Project Owner:	Hudsonville Public Schools
Project Name:	Video Surveillance Expansion
Issue Date:	June 4, 2024

ADDENDUM NO. 1

OVERALL FIRST FLOOR PLAN

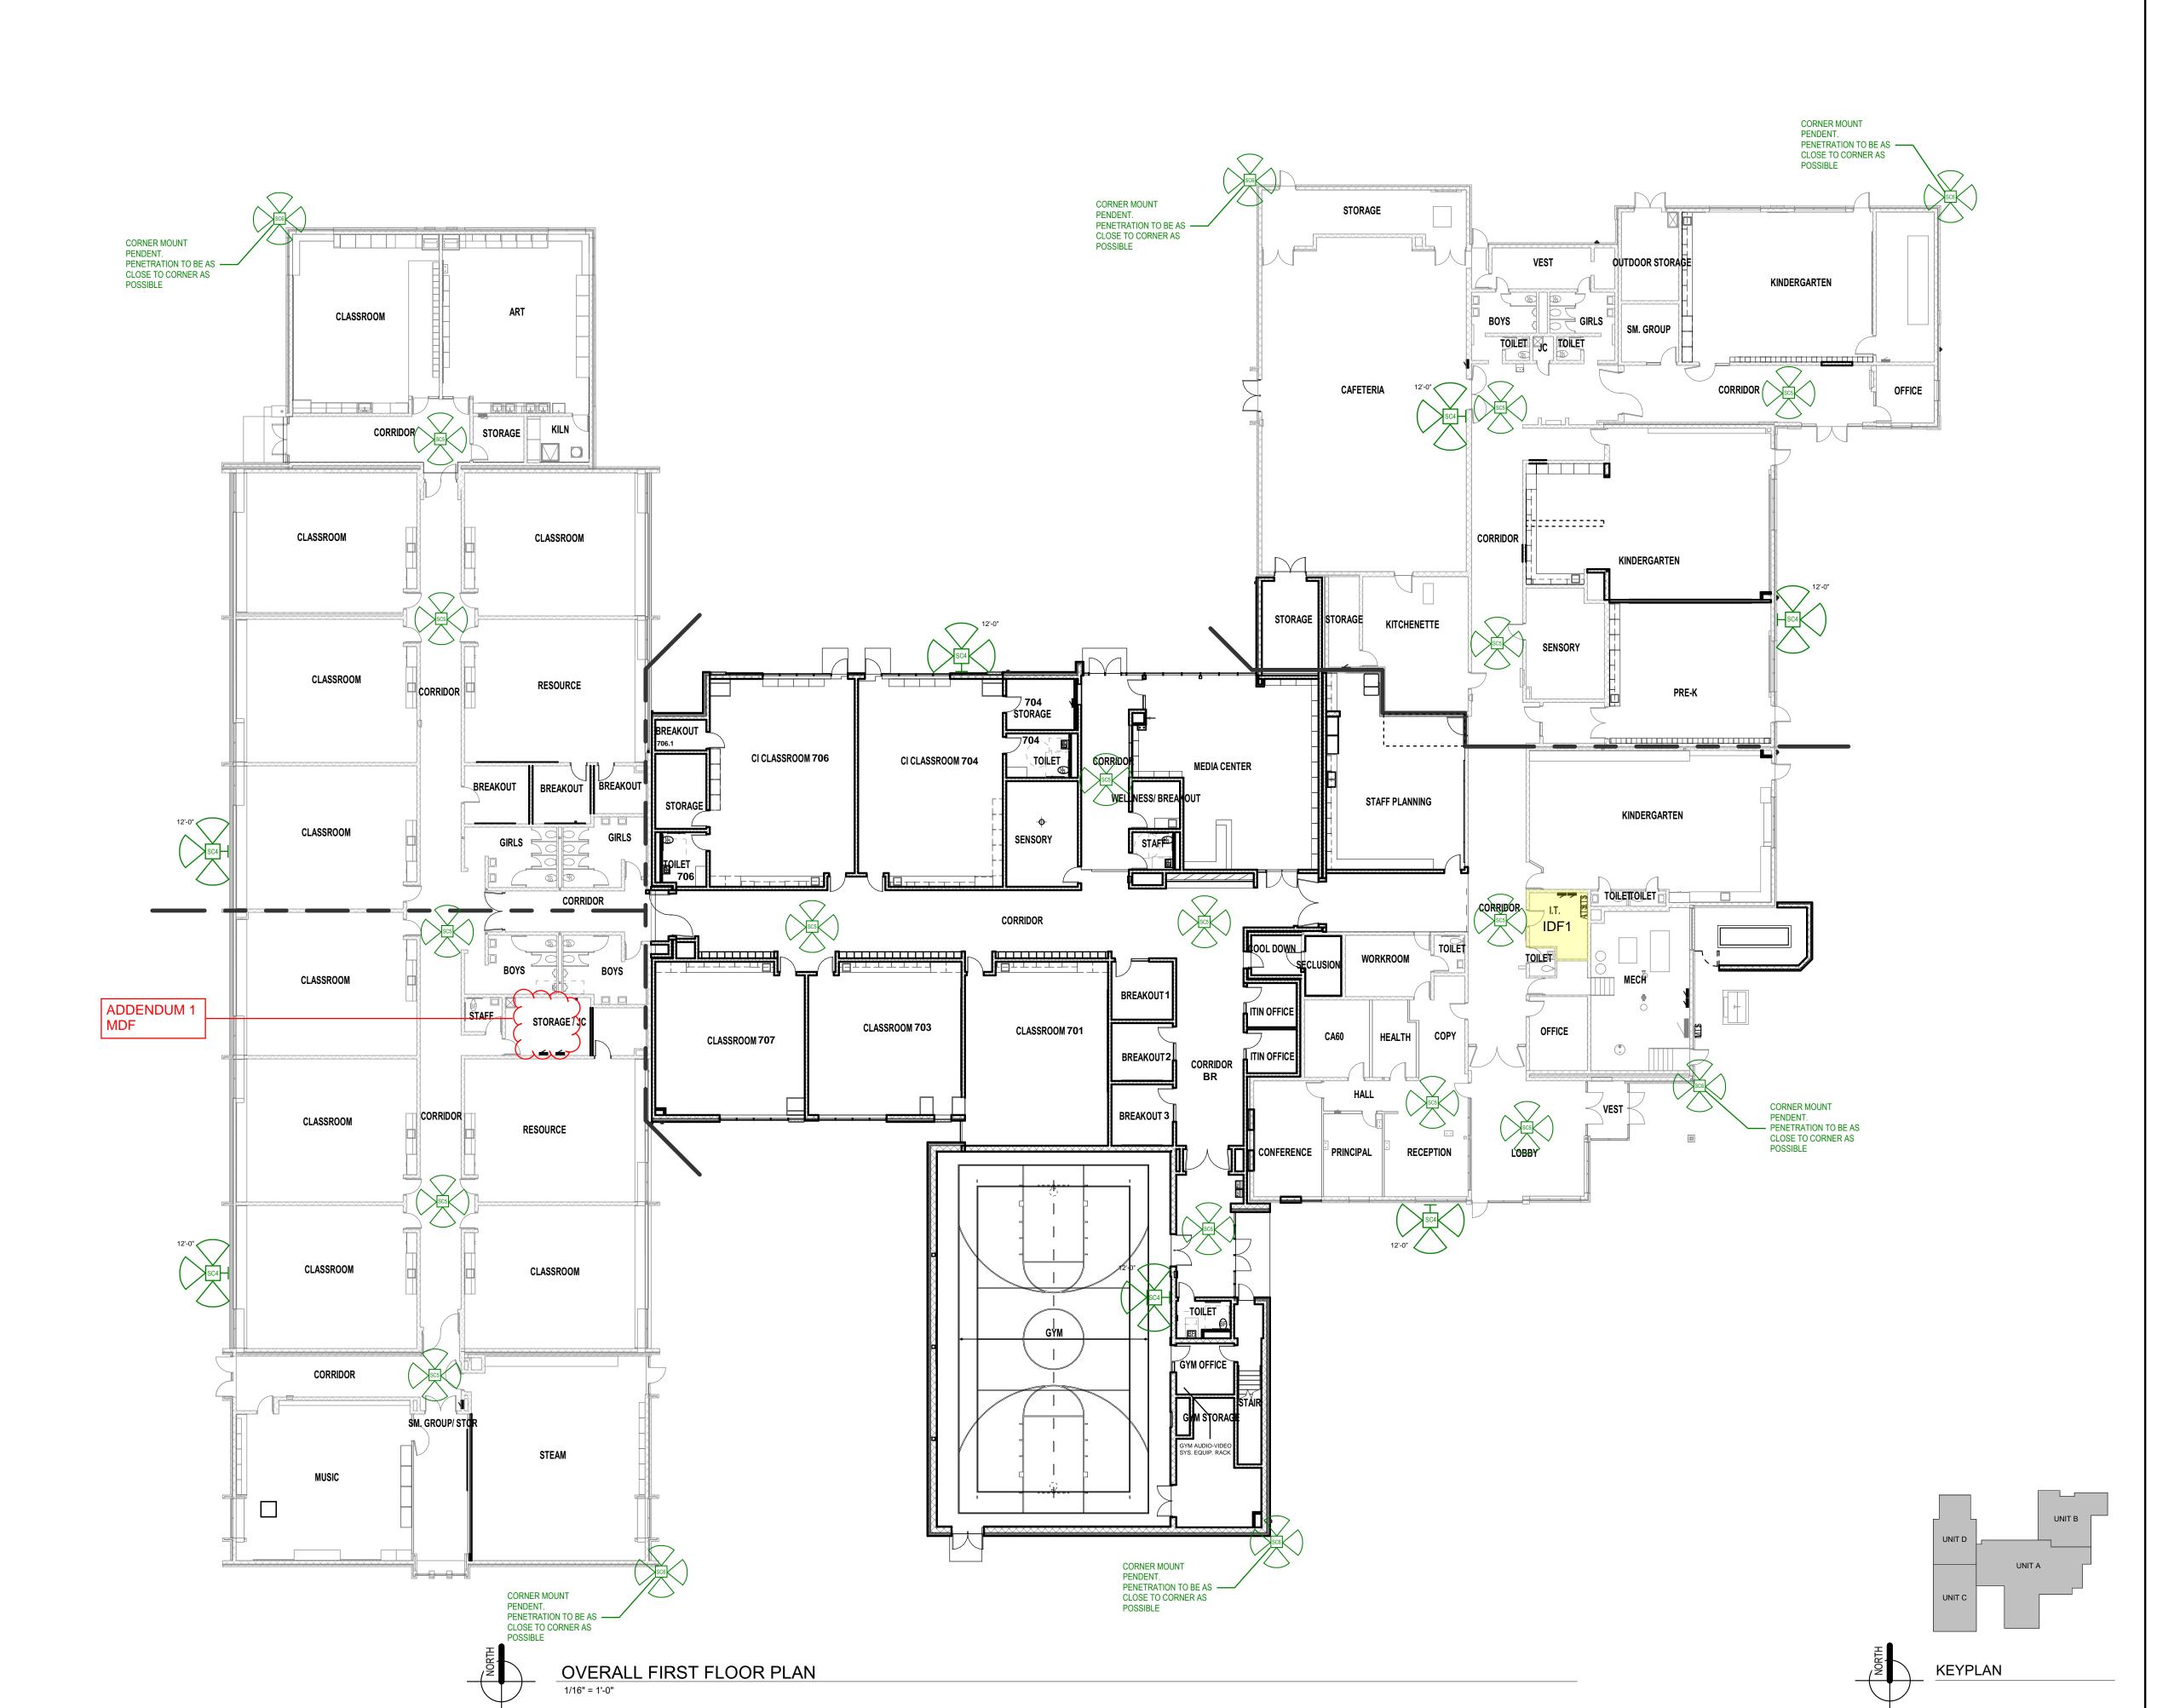
a. CAMSWITCH 8 Plus, POE Network switch, Powered via	
	POE-in, or optional VPSU-57V	
	b. Or Equivalent	
	The Contractor is also responsible for all items listed in section 2.08 BUS UPLOAD	
	Option 3: Contractor to supply all items listed in the RFP in SECTION 28 30 00 - VIDEO MONITORING SYSTEM. If there is any discount in providing both options please note this in your bid response	
AD1 - 2	Bid Forms are hereby revised and attached hereto.	
AD1 - 3	Bauer Elementary Drawing is hereby revised and attached hereto.	
ADI-3	- Note: Only changes are the identification of network closet/s.	
	Early Childhood Center Drawing is hereby revised and attached hereto.	
AD1 - 4	- Note: Only changes are the identification of network closet/s.	
	Forest Grove Elementary Drawing is hereby revised and attached hereto.	
AD1 - 5	- Note: Only changes are the identification of network closet/s.	
	Park Elementary Drawing is hereby revised and attached hereto.

AD1 - 6	- Note: Only changes are the identification of network closet/s.	
	Section 27 10 00 - Low Voltage Cabling is revised and attached hereto.	
AD1 - 7	3.06 SCHEDULE, MEETINGS AND PLANS
